ADDENDUM #1

May 7, 2019

RE: Parking Structure Restoration 2019 at One Government Center

DECK COATING DETAIL AT STAIR TREAD

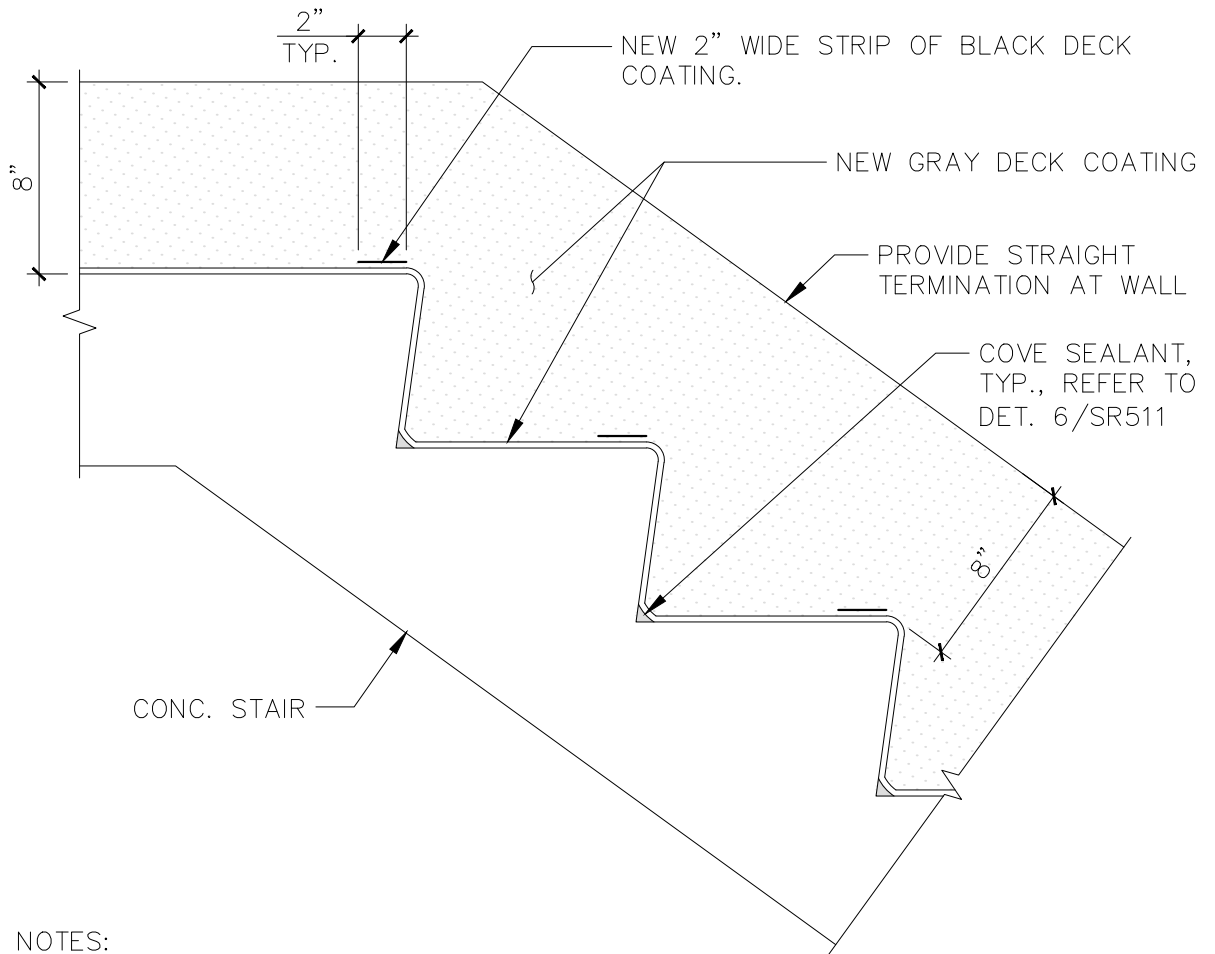
17. Contractor may fully close the structure weekday evenings (after 5:30 PM) and on weekends.
6. Revise Drawing Sheet SR511
- Add Detail 17 Deck Coating at Stair Tread – SEE ATTACHED

Answer: Aluminum strip nosing is not to be replaced. Repair cost to include the removal of aluminum strip nosing and install of new 2-inch wide strip of black deck coating – see attached deck coating detail.

1. 2" WIDE STRIP OF DECK COATING SHALL BE SEEDED WITH AGGREGATE & BACKROLLED.
